TL16C754B Errata

August 2006

Figure 1.

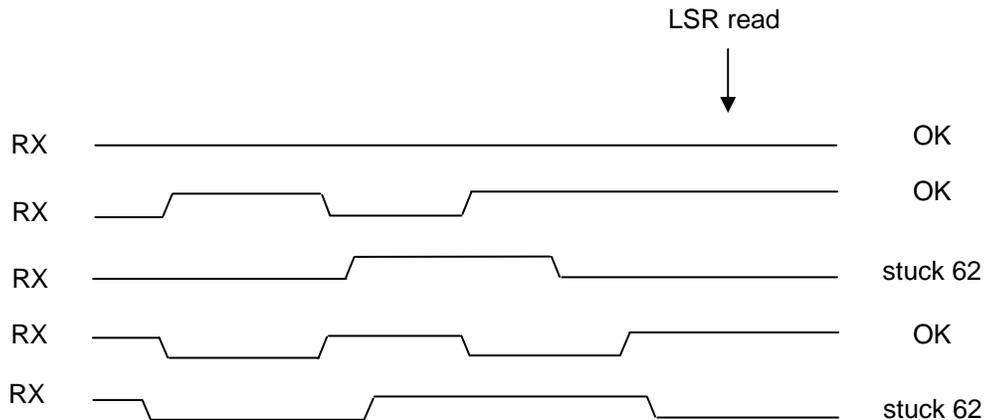
Severity: Moderate
- Problem:** The TL16C754B UART can present a stuck interrupt caused by the LSR being stuck at 62 (overrun indication). The conditions are non-FIFO mode (FCR0=0), LSR error interrupts enabled (IER2=1), and the RX input held low for an extended period. Note that the marking state for RX is high, so this last condition is usually only seen at startup when the RX source has not yet stabilized. Since the device powers up in non-FIFO mode, the problem can occur before FIFO mode has had a chance to be enabled. Figure 1 illustrates when the problem can occur. Each low time on the RX signal is relatively long, and since the divisor registers power up unknown, it is impossible to say with certainty if the low times are sufficient to generate a break character. However, assume that they are. The problem occurs only if more than one break character is detected, which causes an overrun error since the device is in non-FIFO mode. Normally reading the LSR clears the overrun interrupt, but if the RX signal is still low when the LSR is read, the overrun condition will persist erroneously. Once the problem has occurred, changing from non-FIFO to FIFO mode will not clear it out until the RX source is stable.

Work Around: The problem can be avoided by enabling only IER0 (IER2 left at default) and then waiting until a valid (non-error) character is received. The break characters will still be detected and read as 00 in the RHR with the correct status in the LSR. RX source has stabilized when a character with no errors present is detected. Then IER2 can be set, and normal FIFO operation can continue.

Figure 2.

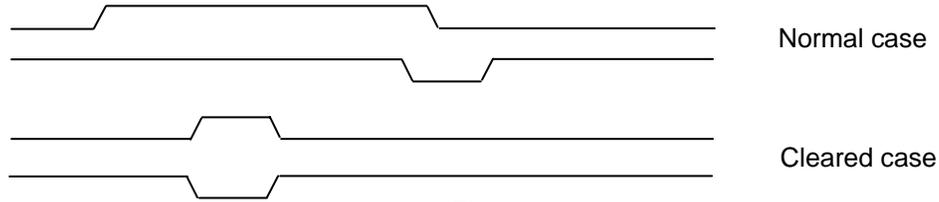
3. **Problem:** The TL16C754B can clear the just set THRE interrupt condition if the IIR read is coincident to the THRE setting. Since IIR reads are generally asynchronous with respect to the THRE setting, the possibility exists for this problem to occur, although it is unlikely. Reading the IIR is one of the normal clearing mechanisms for the THRE interrupt. Most software will read the IIR only as a response to assertion of the INT pin, which means that this overlap cannot occur. This problem is seen only on systems that logically OR the four individual INTA,B,C, and D signals into one signal to the uP. In detecting which channel had the interrupt, it is necessary to read all four channel's IIRs, and this is when the overlap can occur.

Work Around: Read only the IIR that corresponds to the channel that generated the interrupt.
